MONTGOMERY COLLEGE - OFFICE OF PROCUREMENT
GERMANTOWN CAFETERIA RENOVATION, GERMANTOWN CAMPUS

RFP NO.: E621-008

ADDENDUM #1
Issued: April 16, 2021

- To provide the updated drawings as follows:

Drawing Title
PLUMBING PLAN

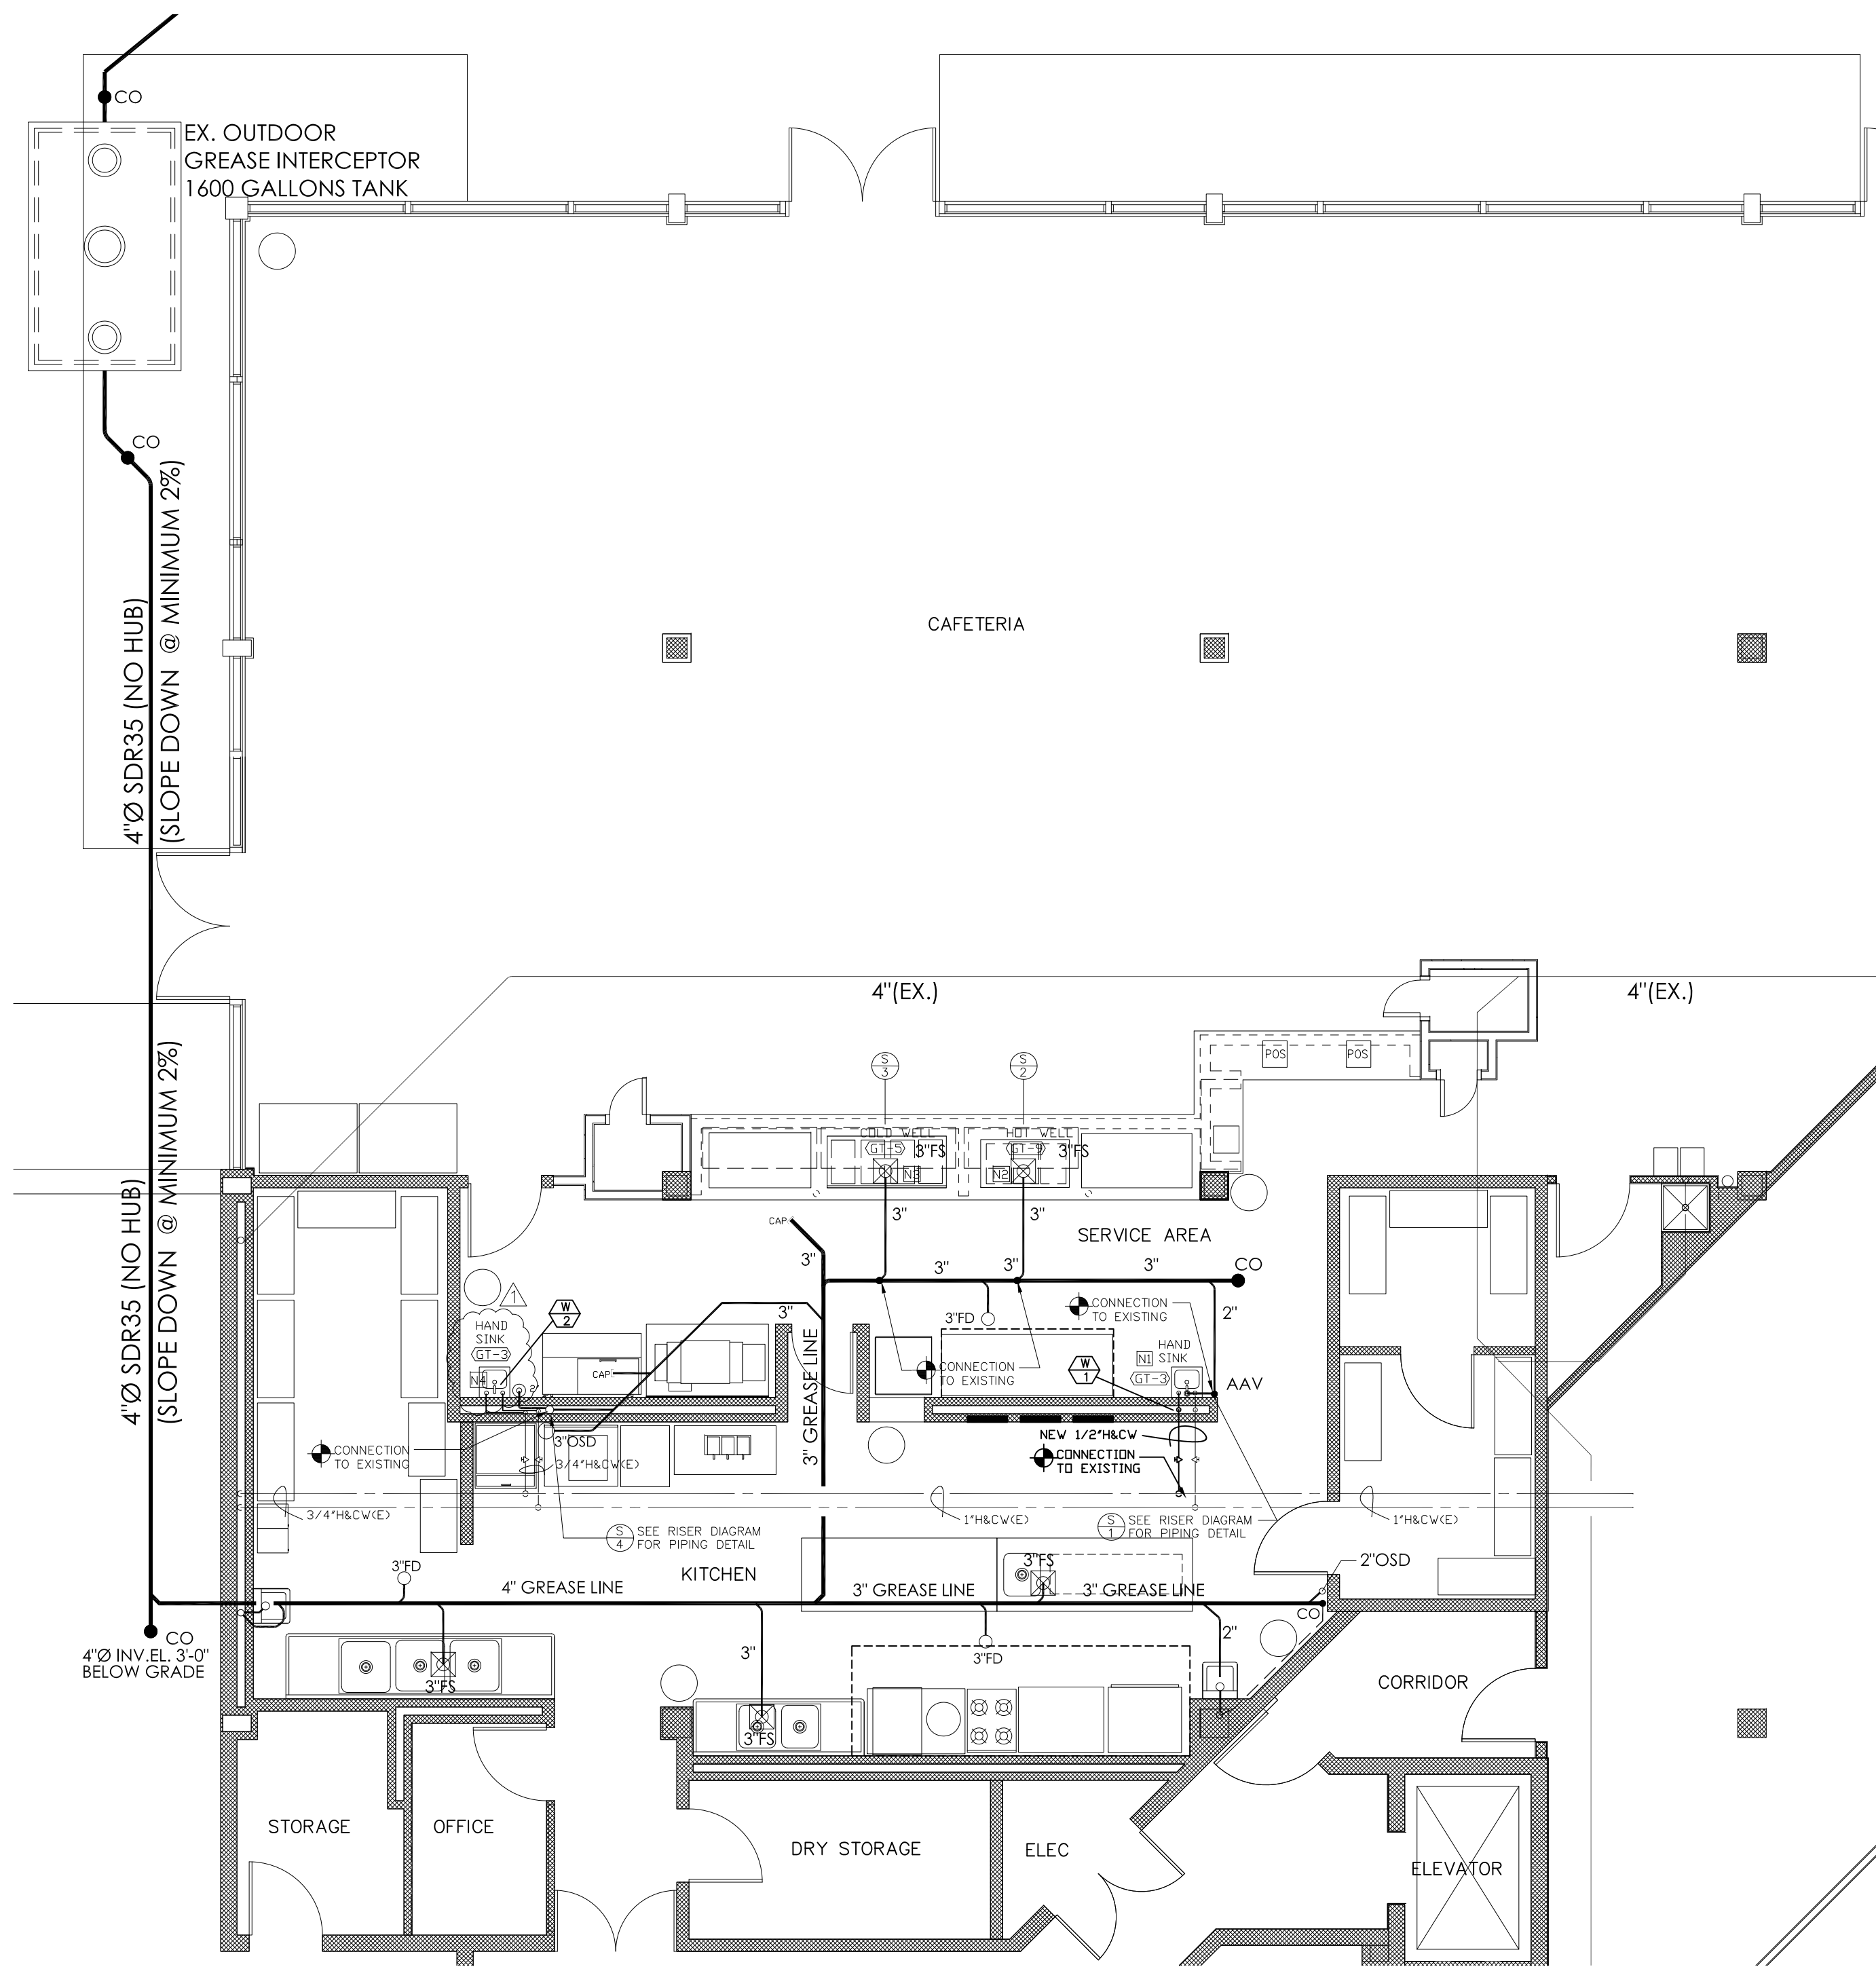
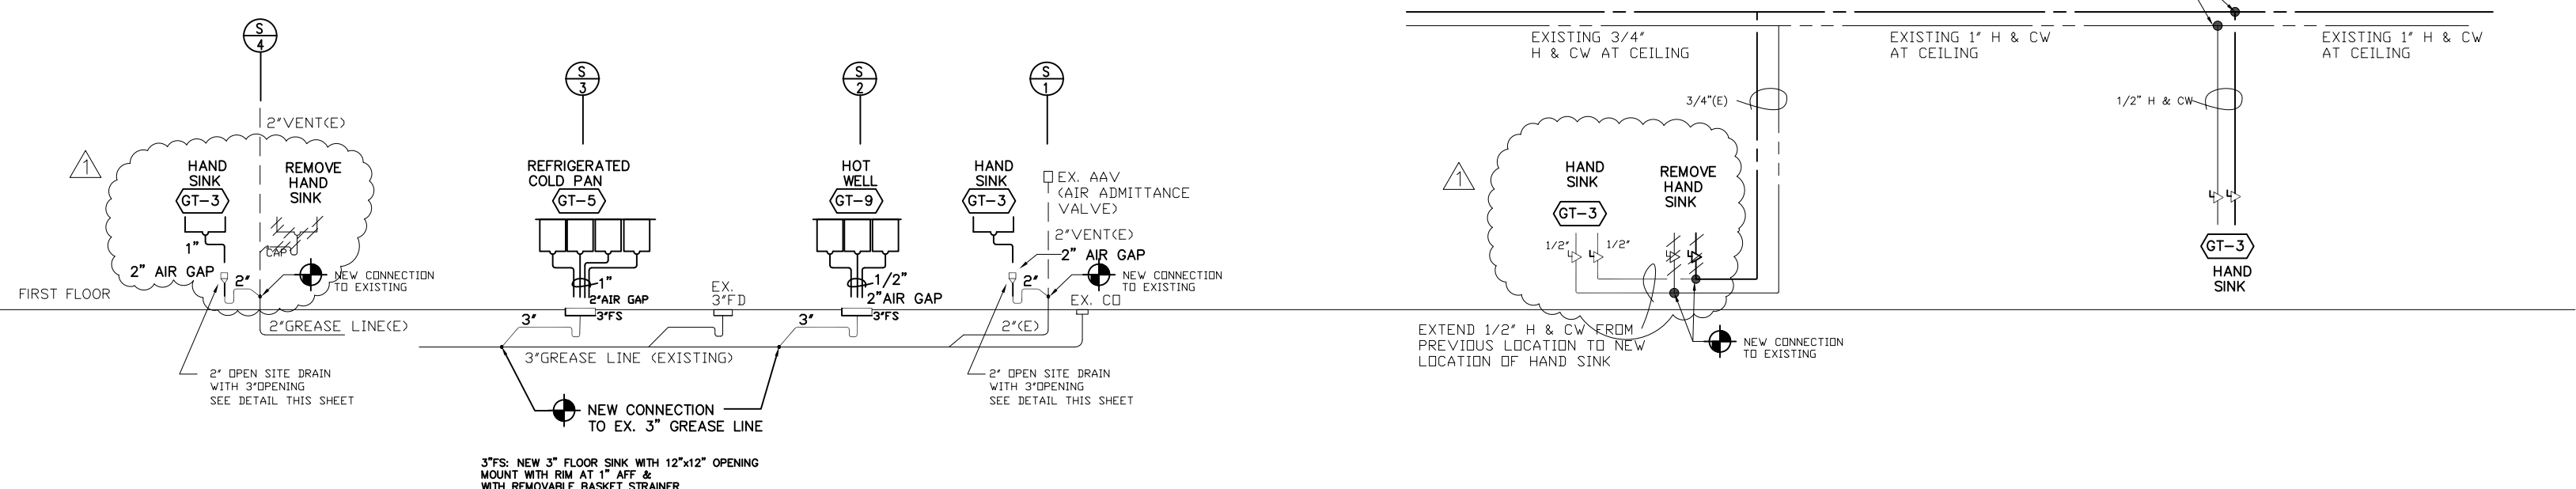
- D1 Remove (2) existing 3" floor sink. Cap waste piping below floor. New floor work by General contractor
- D2 Remove existing hand sink. cap piping inside wall as required extend existing 3/4" hot & cold to new hand sink location
- D3 Remove and/or cap existing (no longer used) 1/2" cold water pipe inside wall as required

- N1 Install new hand sink (GT-3) as shown on plan. Connect 2" waste to existing 2" vent (AAV). Proved 2"x3" pipe adaptor for 1" indirect waste from hand sink. Provide new 1/2" hot & cold water for new hand sink as required
- N2 Provide new 3" floor sink (12"x12" opening with rim at 1" above floor as shown on new plumbing plan) for (3) 1" indirect waste from item GT-9 (hot well)
- N3 Provide new 3" floor sink (12"x12" opening with rim at 1" above floor as shown on new plumbing plan) for (4) 1" indirect waste from item GT-5 (refrigerated cold pan)
- N4 install new hand sink (GT-3) as shown on plan. Connect 2" waste to existing 2" waste and vent. Proved 2"x3" pipe adaptor for 1" indirect waste from hand sink. Connect new 1/2" hot & cold water for new hand sink as required. Existing 3/4" hot & cold water pipe above ceiling

BID ADDENDUM # 1 (HAND SINK) 4/14/2021
